Moreland
City Council

COUNCIL AGENDA

5.2 108A NICHOLSON STREET, BRUNSWICK EAST - MPS/2020/619

Figure 2: rear boundary building envelope outline under the DDO20 (sketch plans, 6 July 2021).

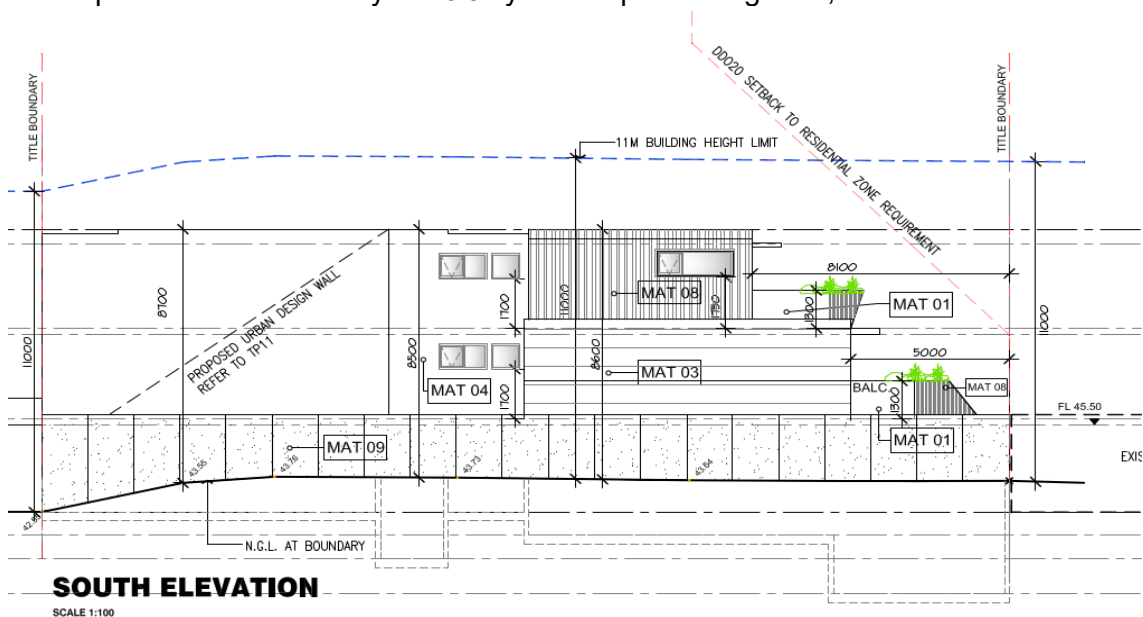
The design response proposes a wall along the east boundary less than 2 metres in height and upper level setbacks well within the allowances of DDO20. The rear boundary building envelope outline under the DDO20 is shown in the context of the development as amended by the 6 July sketch plans in figure 2, below:

Figure 4: Mark-up plan of the required setbacks to the rear half of the building to comply with Standard B20.

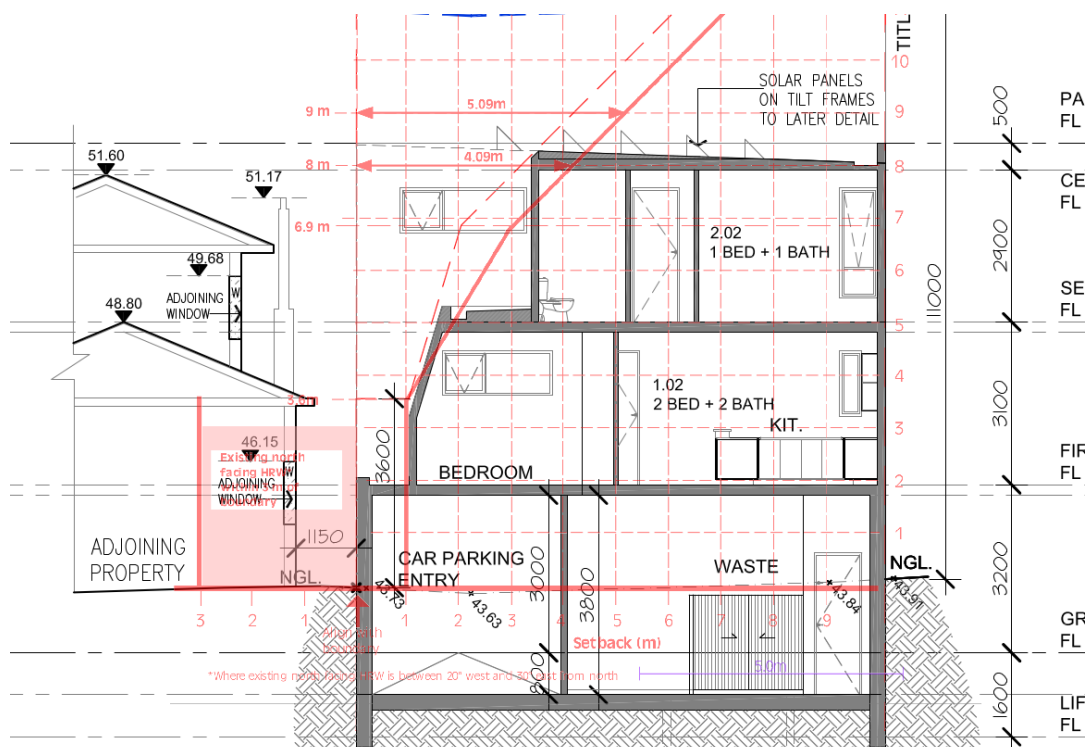
The section C-C diagram of the sketch plans has been marked-up to illustrate the recommended change (see solid red line in Figure 4 below) to the rear half of the building.

- The wall on the south boundary shortened at first and second floor levels (associated with Apartments 1.01 and 2.01) so that it does not extend past the western-most north facing ground floor window at 108 Nicholson Street to the south.
- The south elevation walls of Apartments 1.02 and 2.02 modified to fully comply with Standard B20 at Clause 55.04-4 (North facing windows objective).

- i. The wall on the south boundary shortened at first and second floor levels (associated with Apartments 1.01 and 2.01) so that it does not extend past the western-most north facing ground floor window at 108 Nicholson Street to the south.

- ii. the south elevation walls of Apartments 1.02 and 2.02 modified to fully comply with Standard B20 at Clause 55.04-4 (North facing windows objective).
